HISTORIC AND DESIGN REVIEW COMMISSION May 01, 2020

HDRC CASE NO: 2020-144

ADDRESS: 919 E CROCKETT ST

TYPE OF WORK: Fencing

Plot Plan

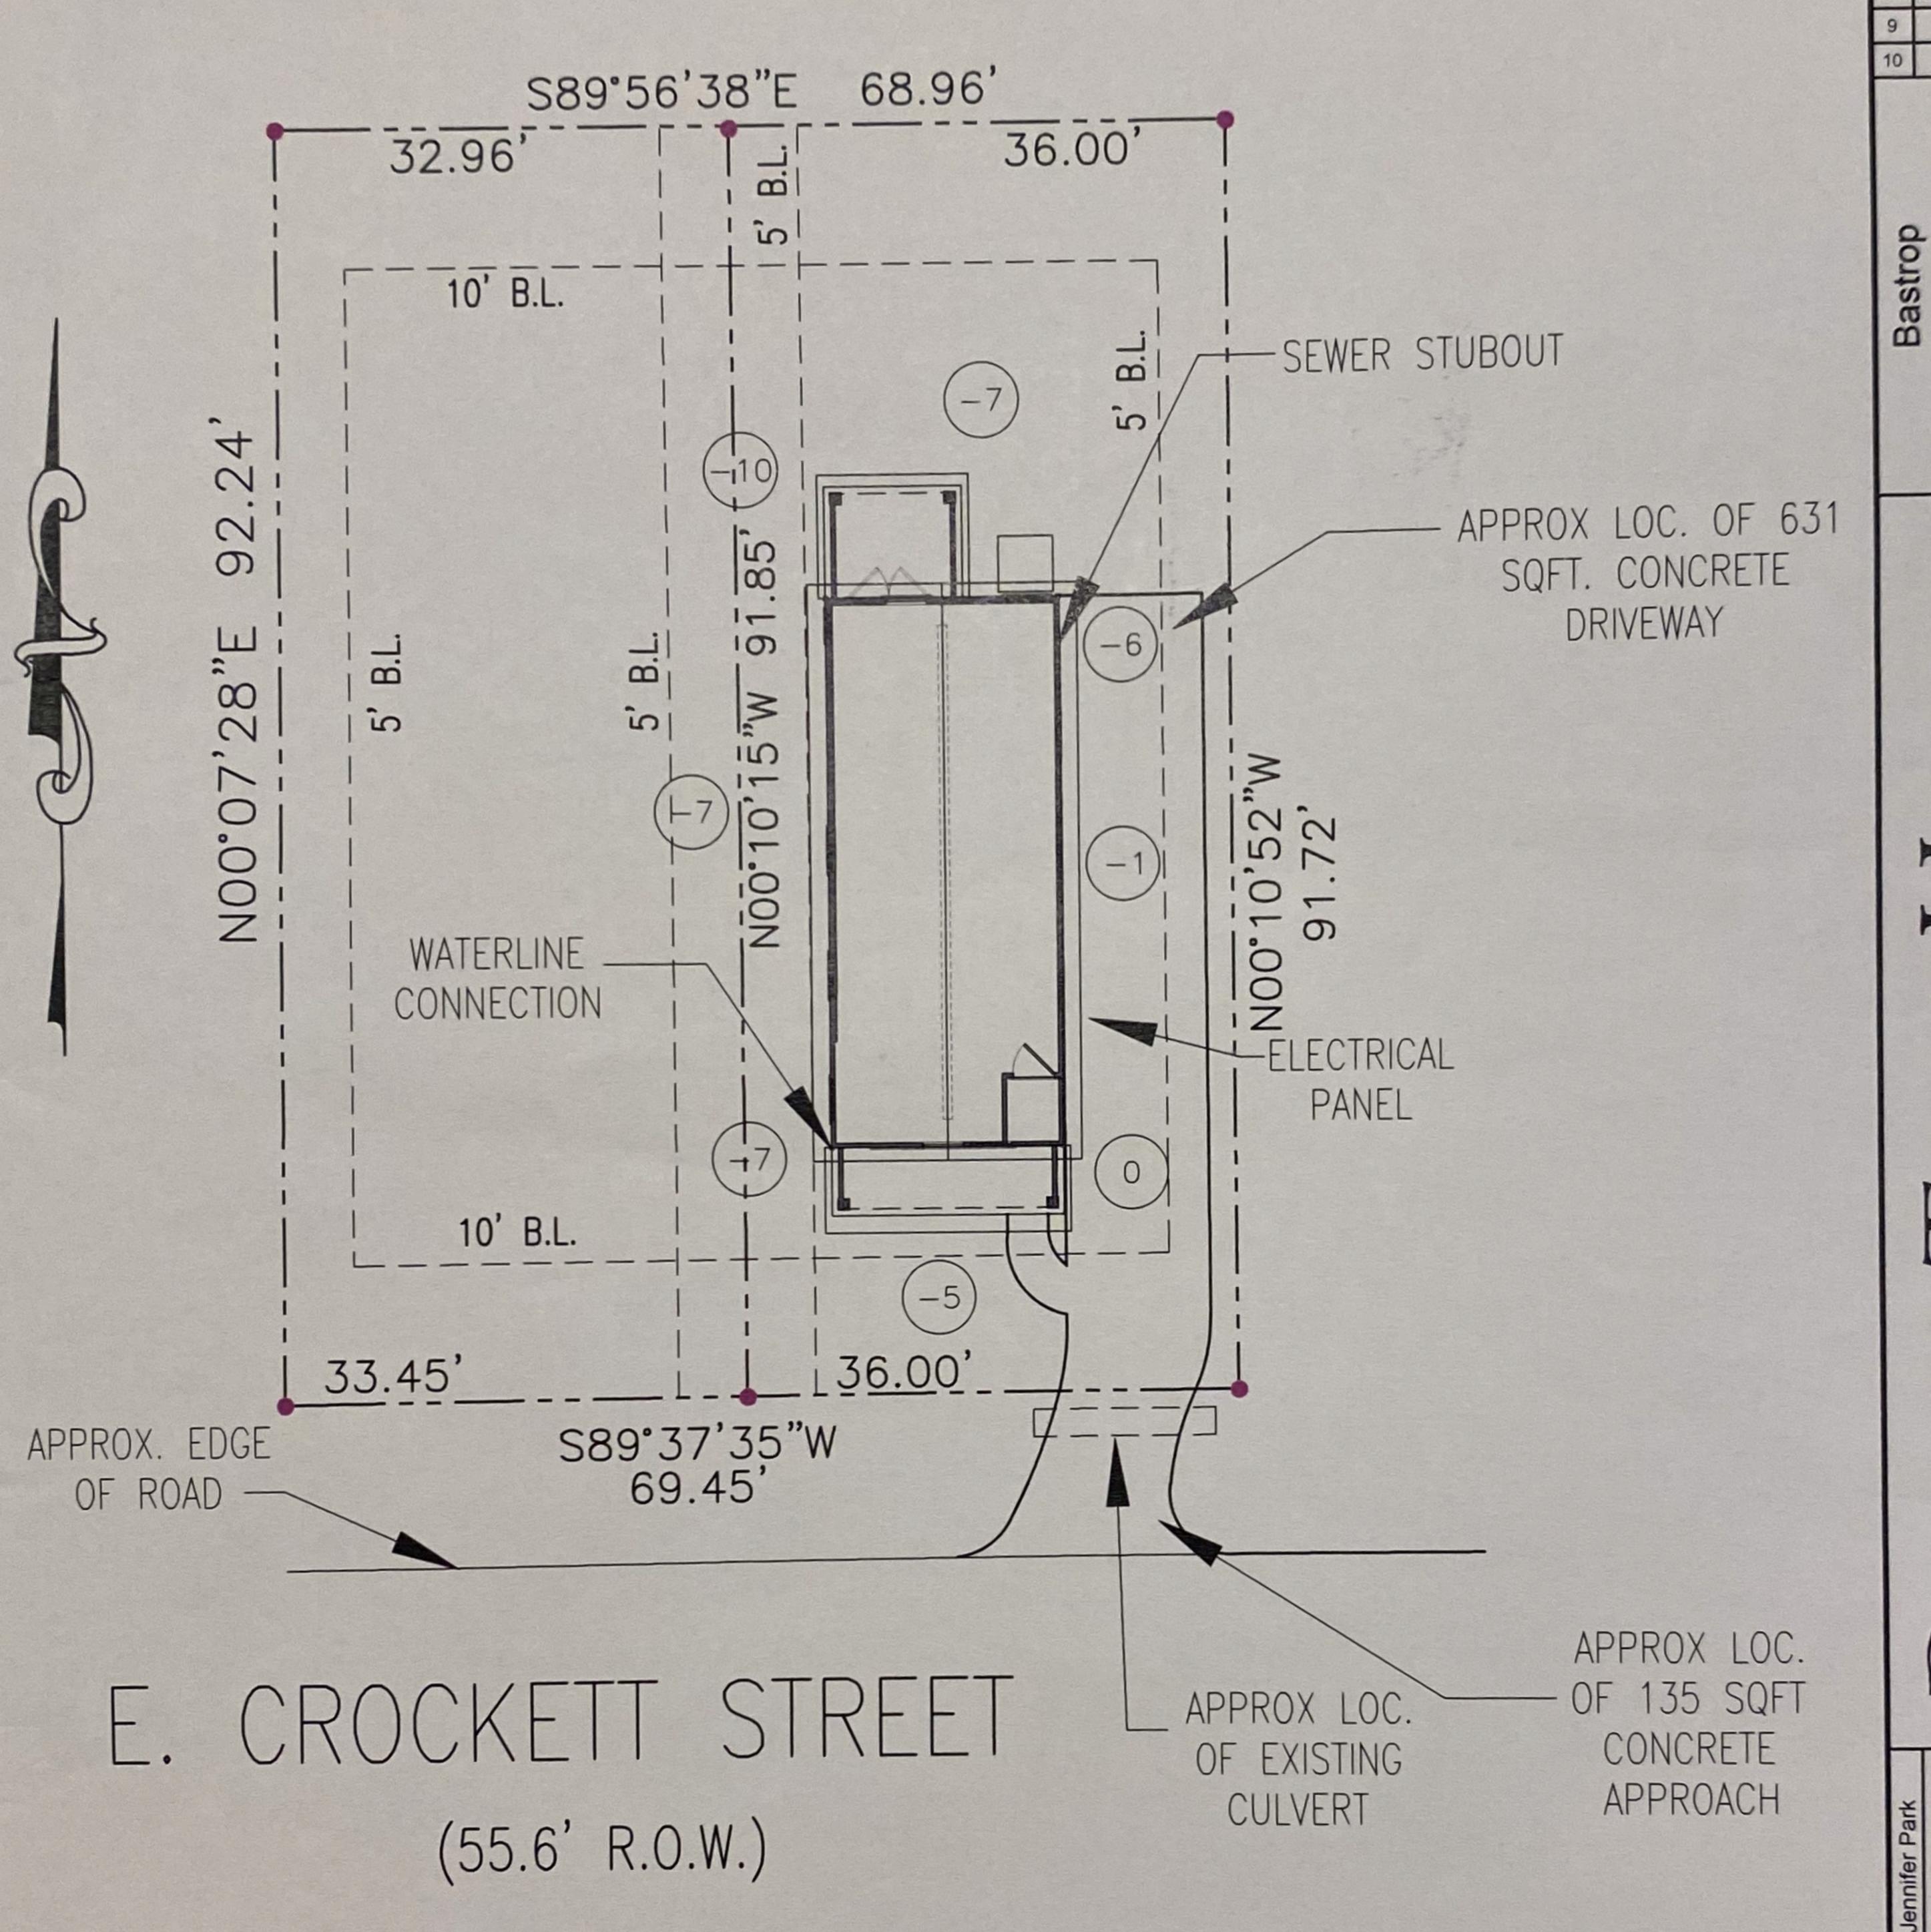
- e. FENCE HEIGHT The applicant has proposed to install a fence with height of 6 feet from the rear carport and stepping down to 4 feet in height before approaching the front yard to meet the existing side fence. Per the Guidelines for Site Elements 2.B.iii, applicants should limit the height of new fences and walls within the front yard to a maximum of four feet; the appropriateness of a front yard fence is dependent on conditions within a specific historic district. Staff finds the proposed height is consistent with the Guidelines.

- i. That the fence height is no taller than 4 feet at any portion in front of the front facade plane.
- ii. That any solar or mechanical gate equipment, if used, be concealed or minimally visible behind the fence from the public right of way.
